# LINCOLN PARK STADIUM IMPROVEMENTS

## STOCKER STADIUM

RFI No.	Subject	Posted
1	Vertical Reinforcing Bar Placement at Vertical Cores	6/14/2011
2	Locations of Floor Sinks	6/24/2011
3	Construction Base Elevation 100' 0"	6/14/2011
4	Pile Wall Thickness	6/14/2011
5	Anchor Bolt and Base Plate Finish	6/24/2011
6	Bulletin #1 Plumbing Clarifications	No Post
7	Chase Space for Water Closet Carriers	No Post
8	Elevator Shaft Opening Dimension	7/18/2011
9	Deletion of Area Drains at Dugouts	No Post
10	Trench Drains at Dugouts	7/20/2011
11	Location of Dugout Pump Controls	7/18/2011
12	Surge Pump Connection to Storm Drains	7/18/2011
13	3rd Base Dugout Location	7/19/2011
14	Confirmation of Hot Dipped Galvanized Finish for Anchor Bolts	7/20/2011
15	Height of Press Box Work Surfaces	7/20/2011
16	Added File at West Shear Wall Foundation	7/21/2011
17	Waterproofing at the Dugouts	7/20/2011
18	Location of Floor Sink at Catering Kitchen 105 Walk-In Freezer	No Post
19	Thickness of Piles Along Grid Line 1.2	7/26/2011

100% CONSTRUCTION DOCUMENTS

**A2.30**

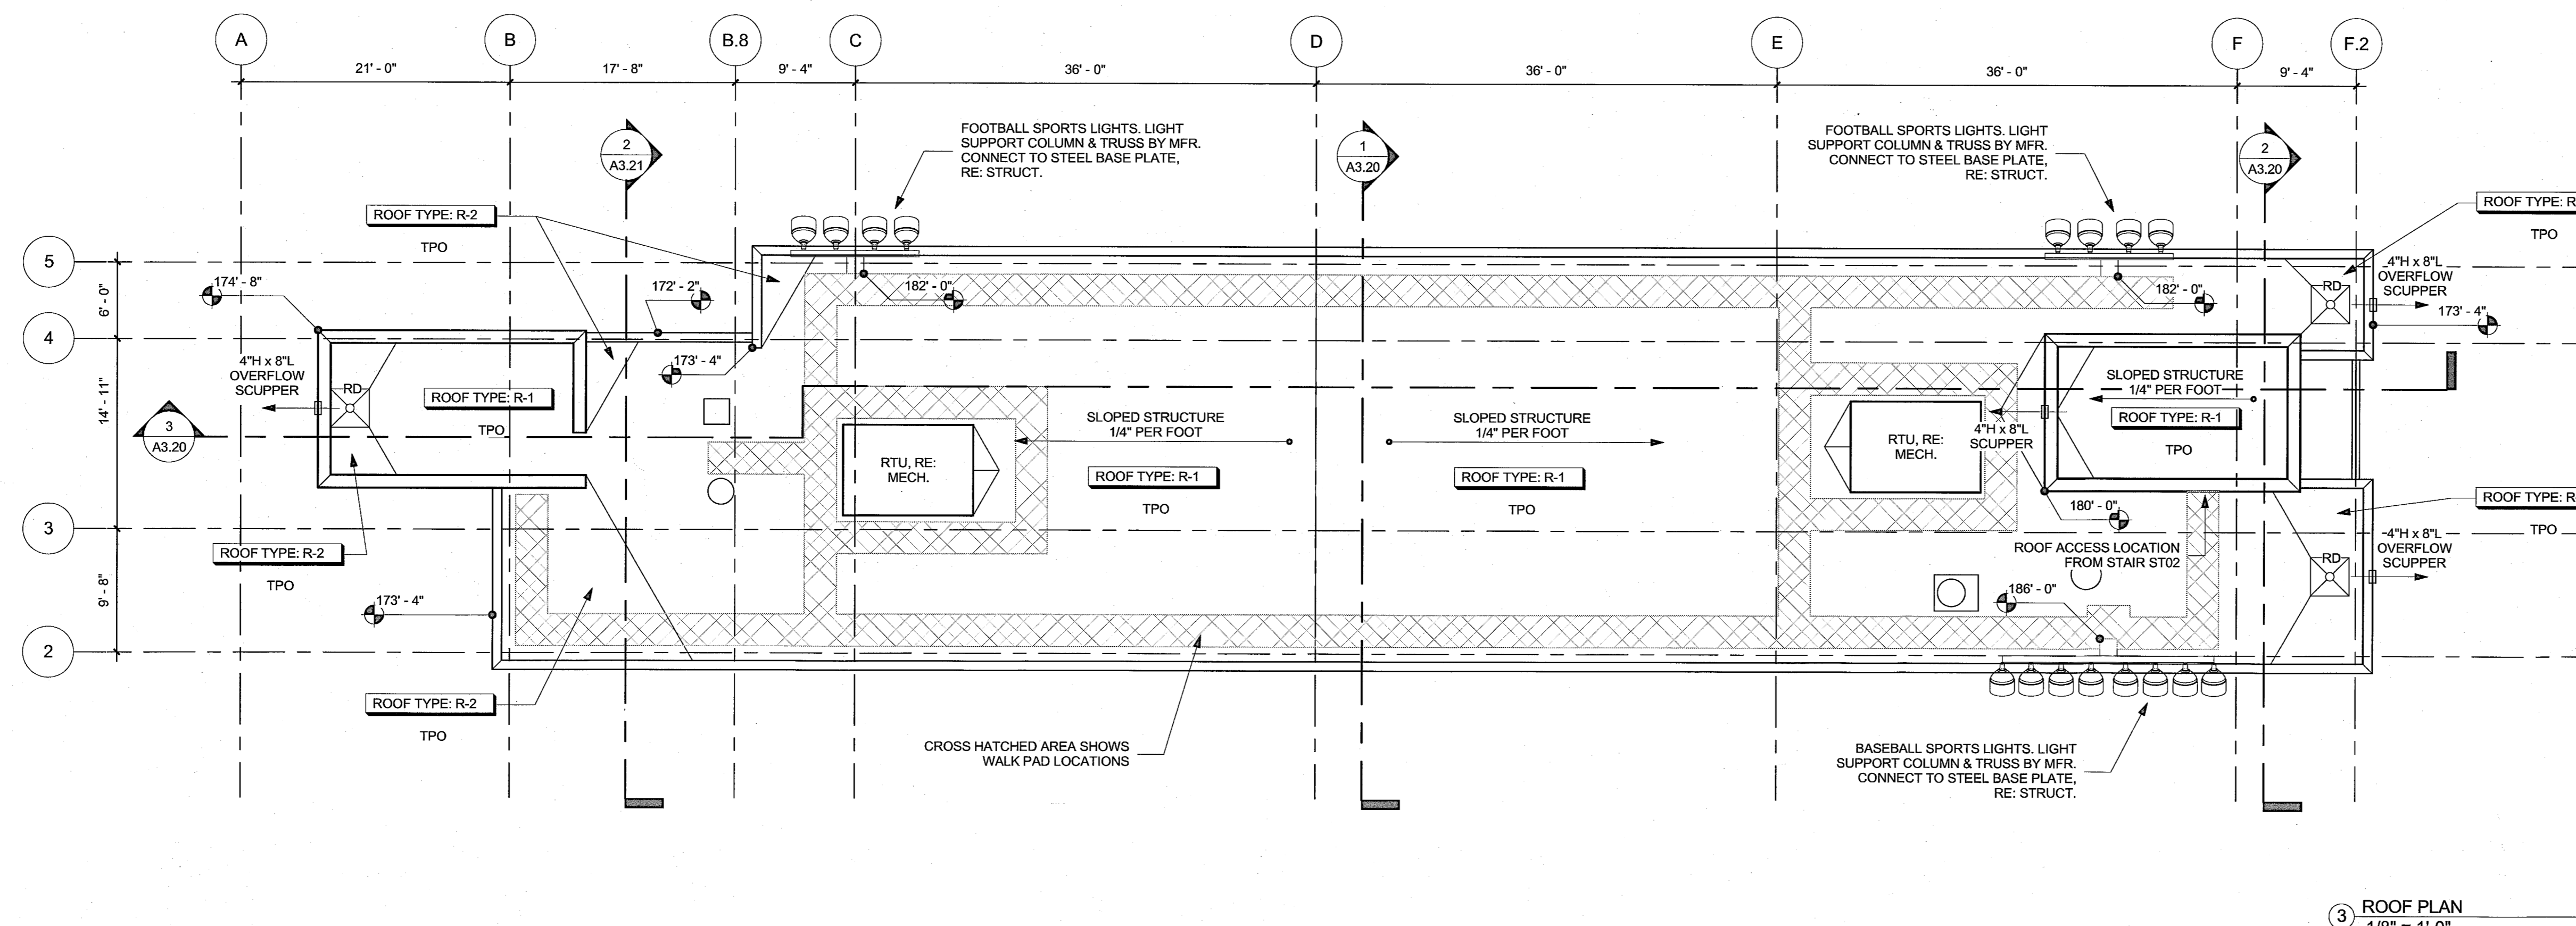
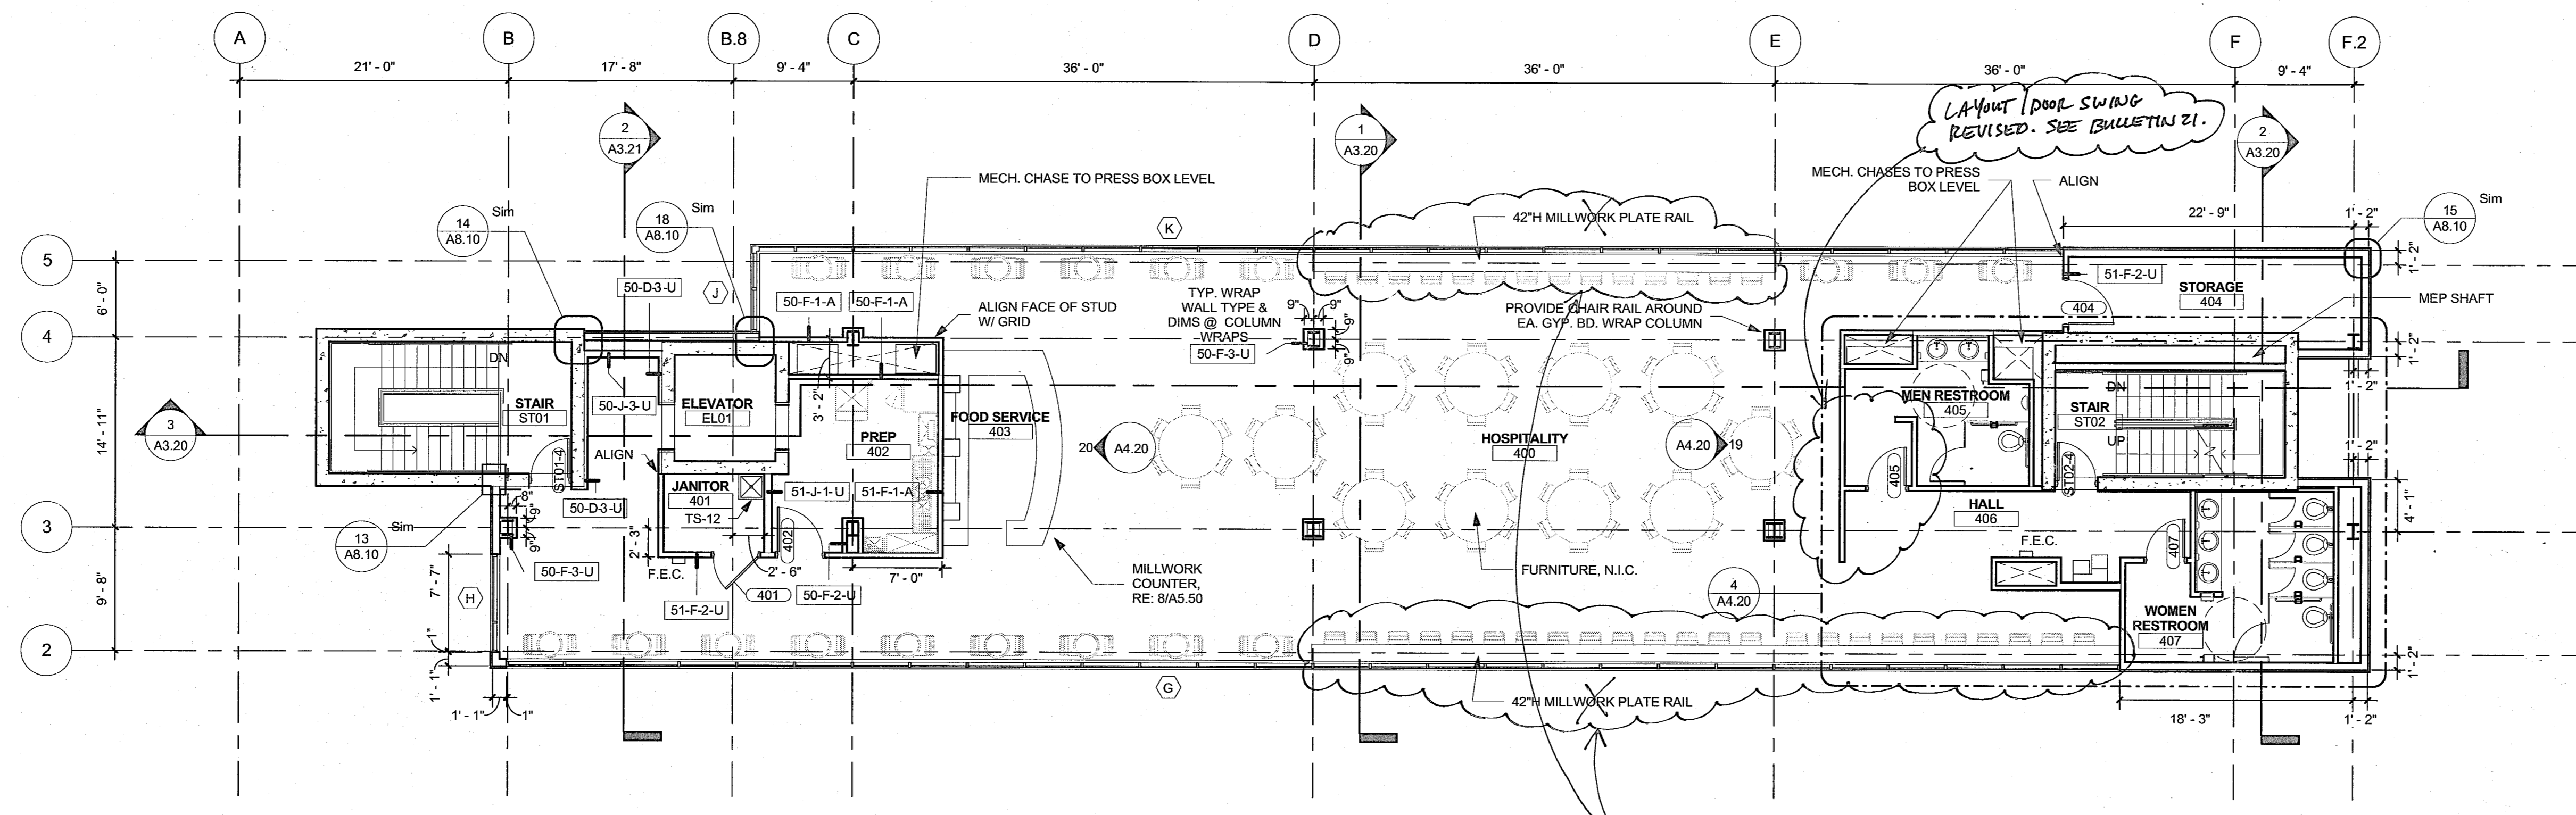
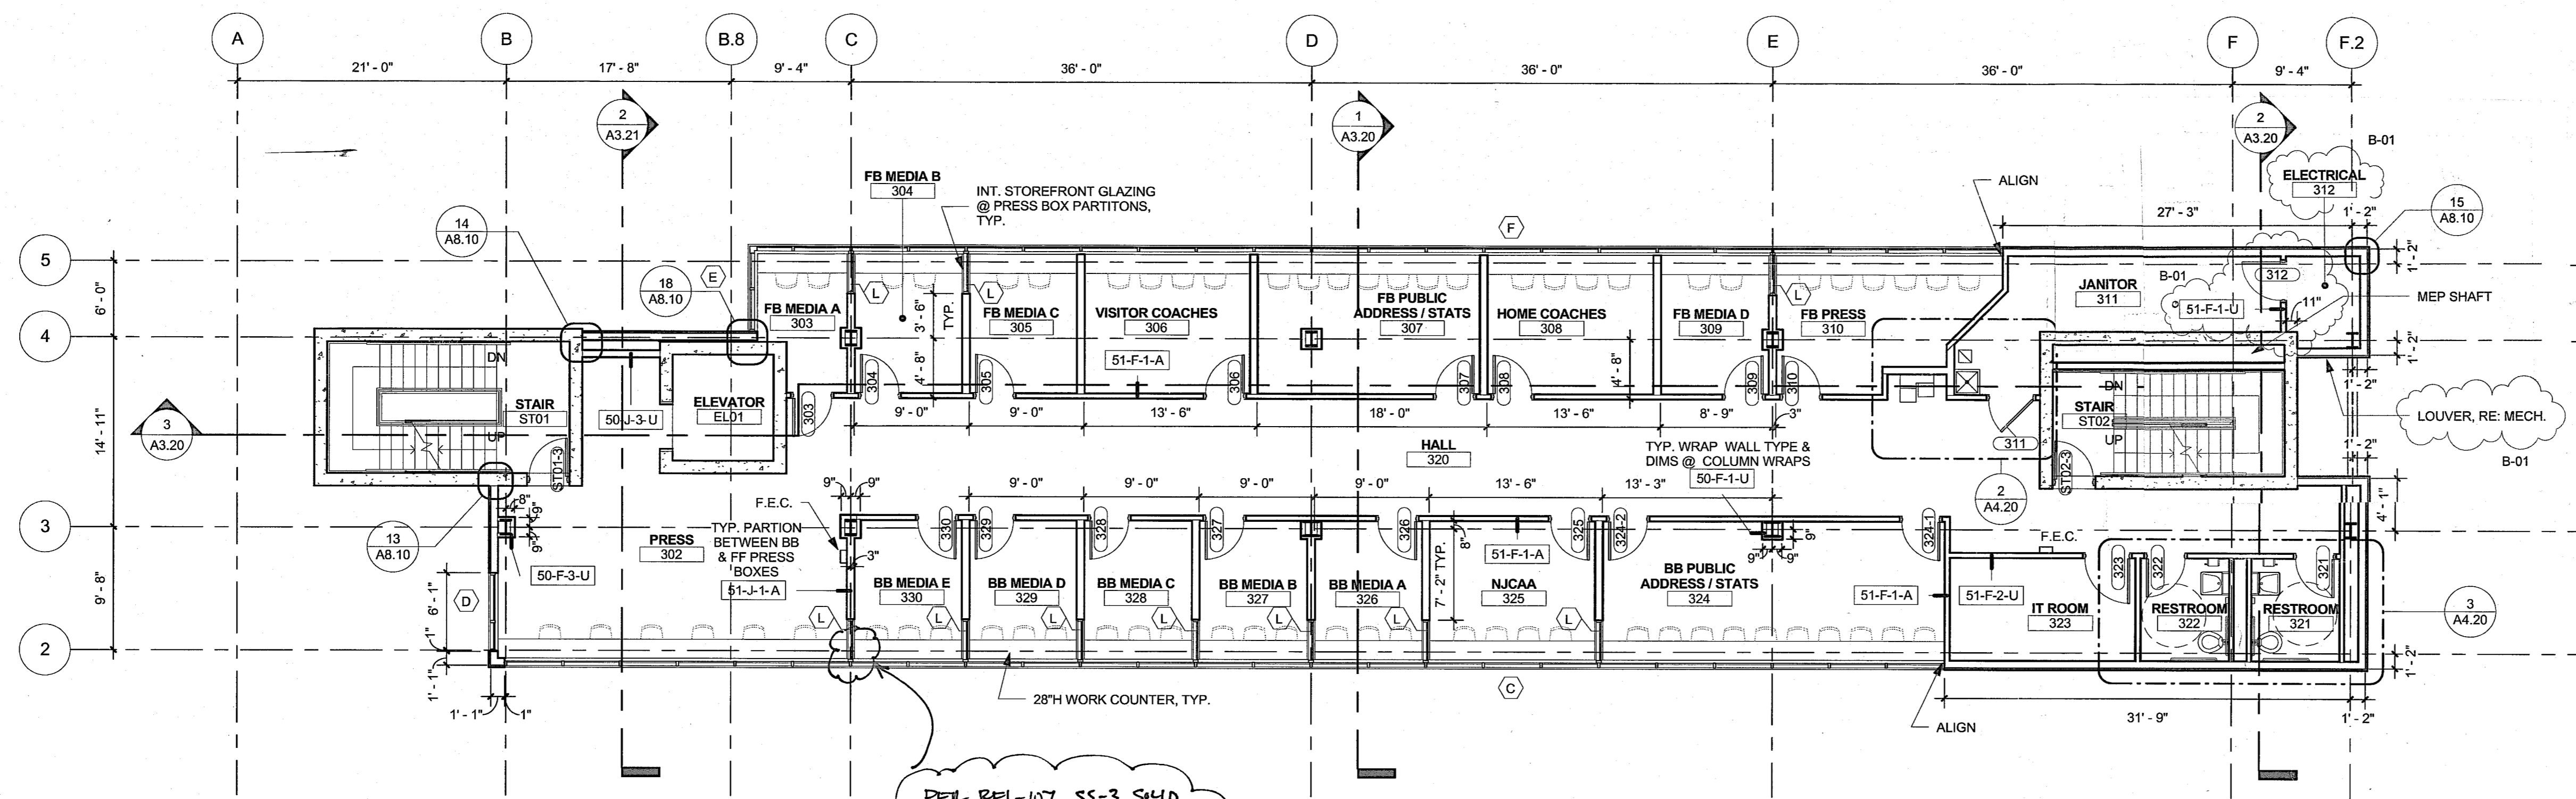
PER RPI-107, SS-3 SH40 SURFACE SILLS ADDED AT SECTIONS OF SILL AT TYPE "L" WINDOWS. TYP. THROUGHOUT PRESS BOX LEVEL.

LA VANT POOL SWING REVISED. SEE BULLETIN 21.

2 PLAN EAST ELEVATION  
1/8" = 1'-0"

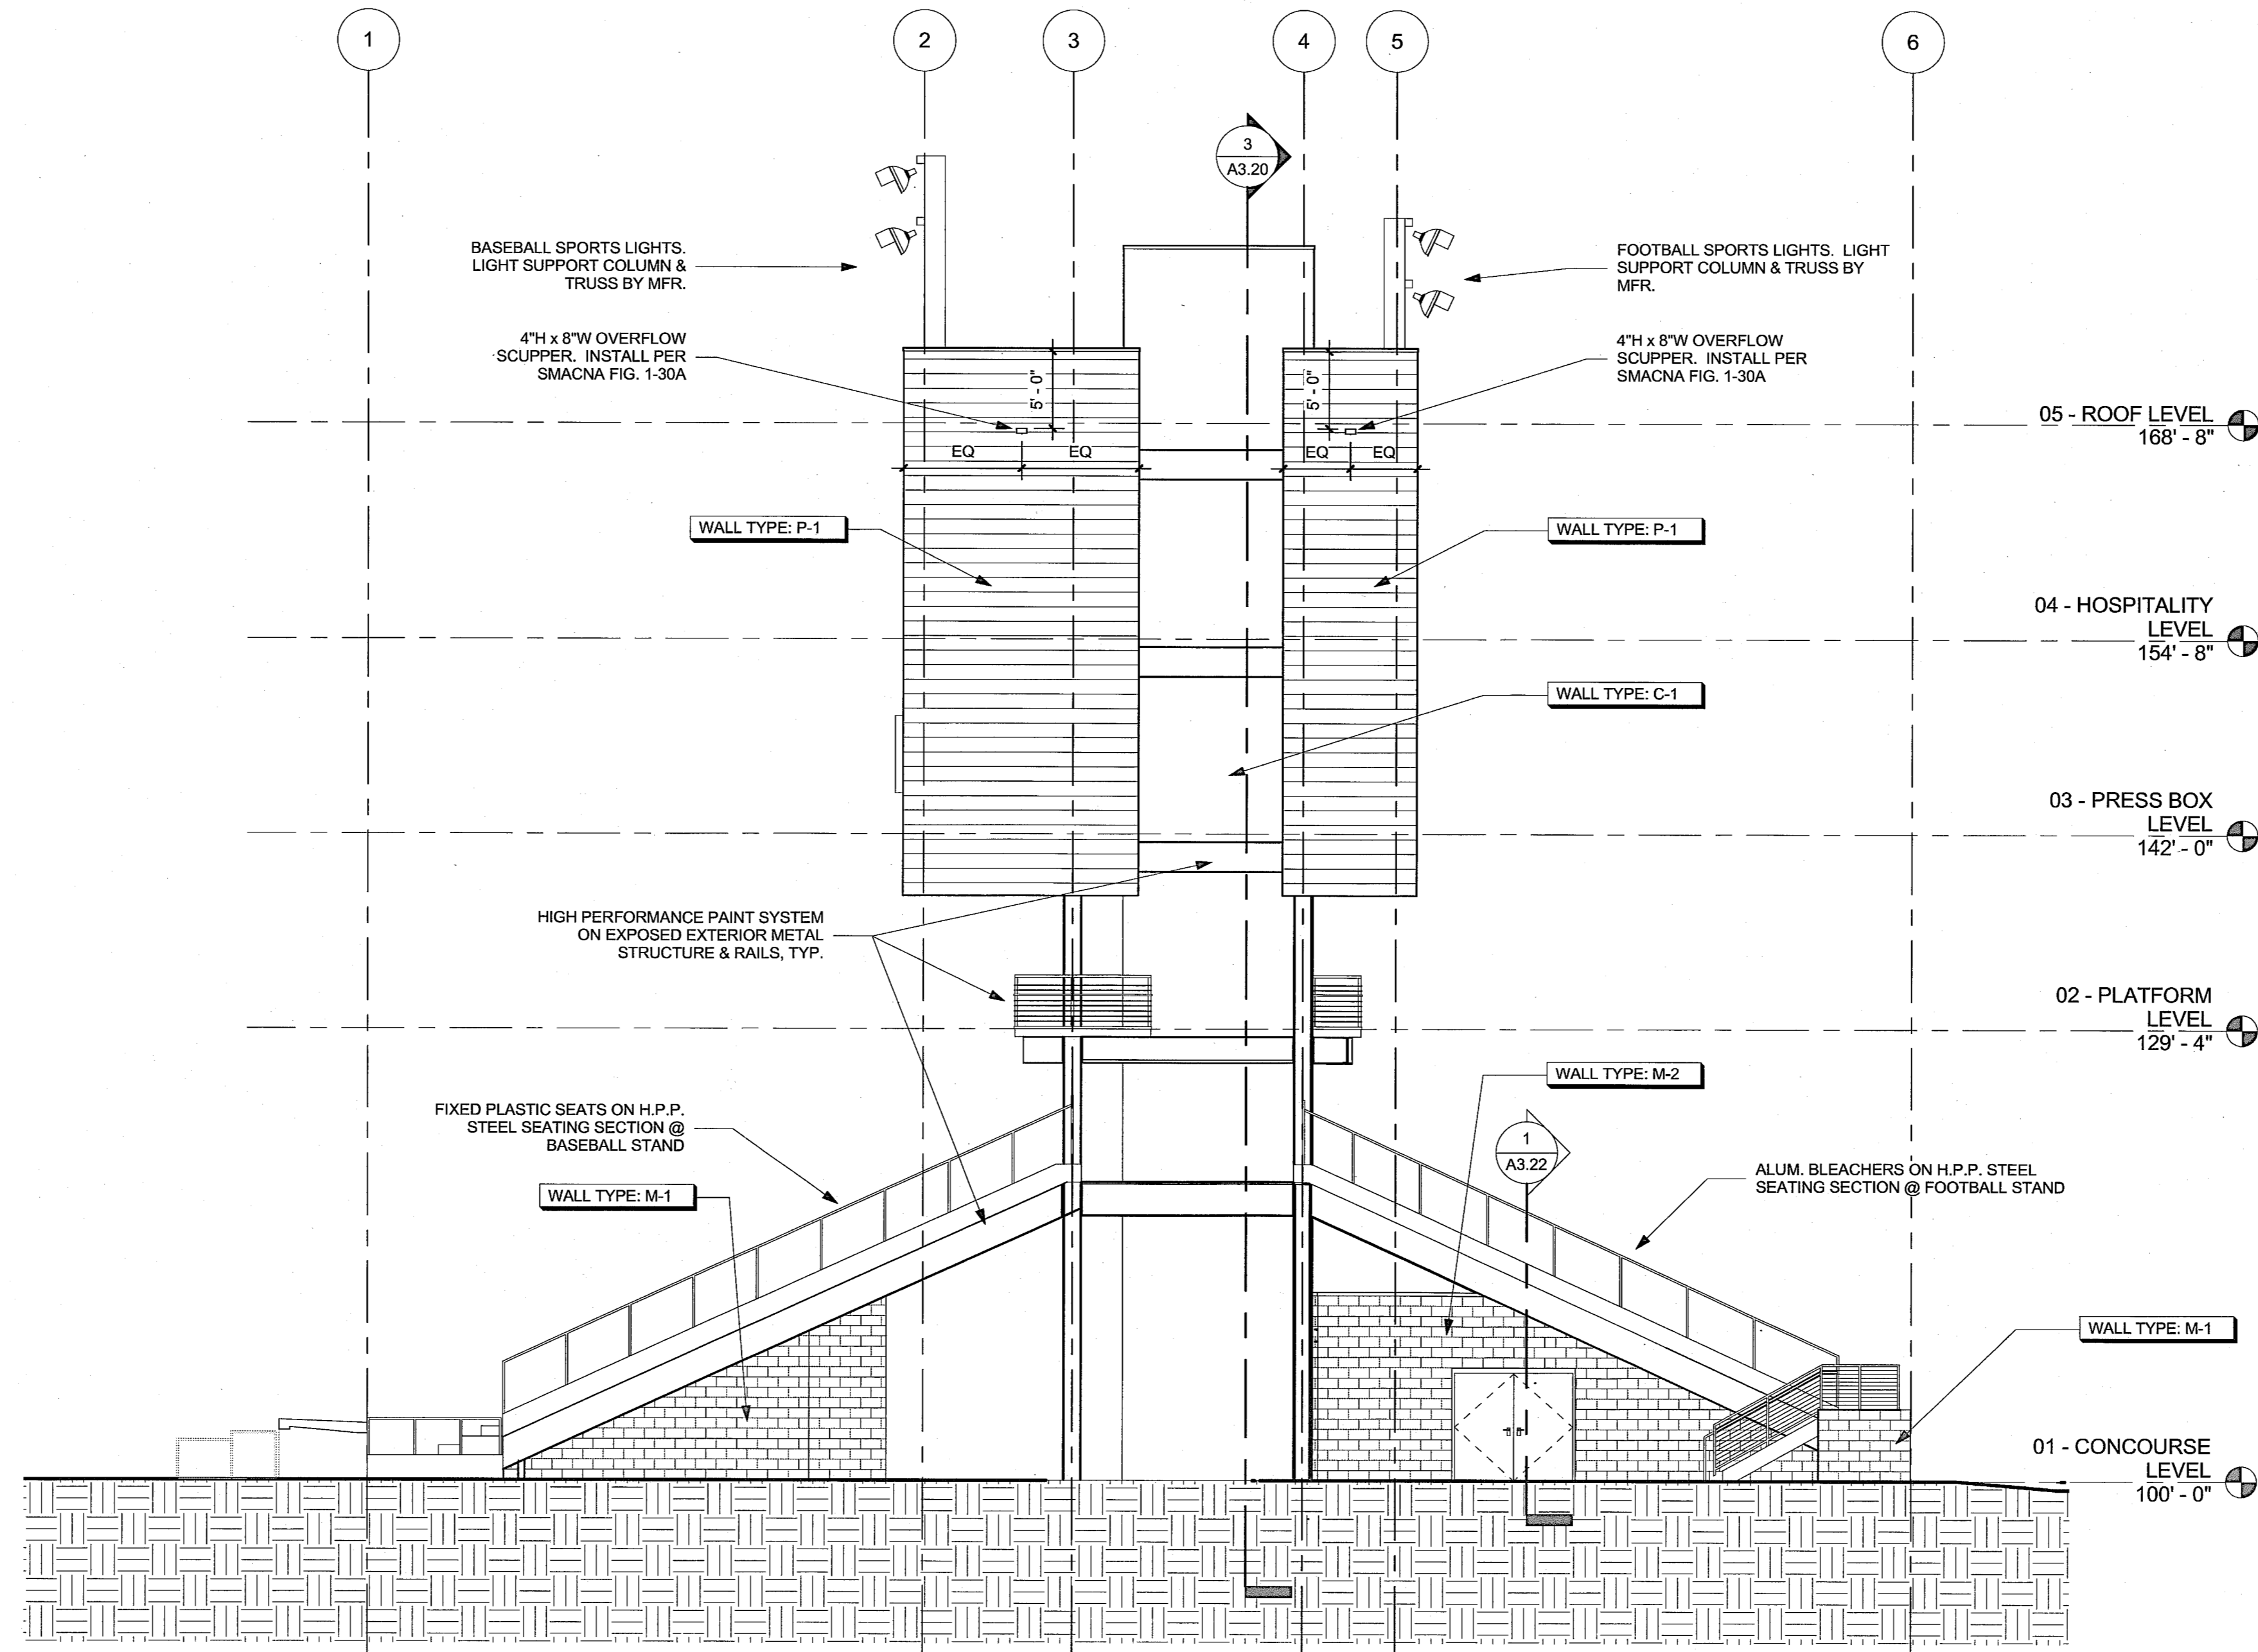
PLATE RAILS DELETED PER BUR-012
